IEEE 802.11
Wireless Access Method and Physical Layer Specifications

Title: **Bit Ordering**

Abstract: **This paper proposes a tightening up of the definition of bit ordering within IEEE 802.11.**

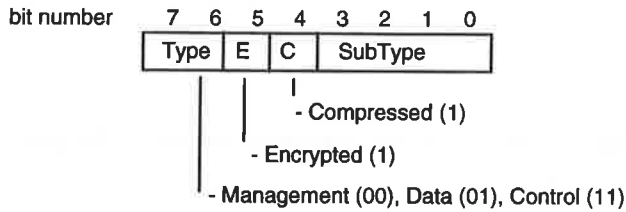
From AP bit 0,
To AP bit 1,
Retry bit 2,
Power Management Mode bits 3 and 4,
Elements present bit 5,
More bit 6,

Poll bit 7,
CF ACK bit 8.

2.5. Frame Format Diagram

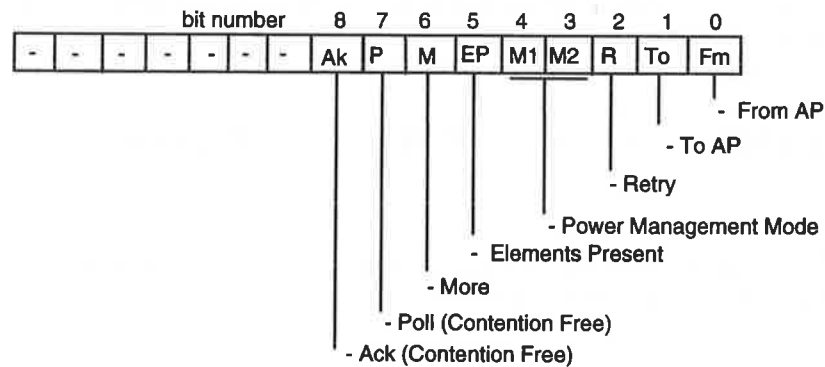
Type Field Format

Control Field Format

Sub Type bits 0 to 3,
Compressed bit 4,
Encrypted bit 5,
Type bits 6 and 7.
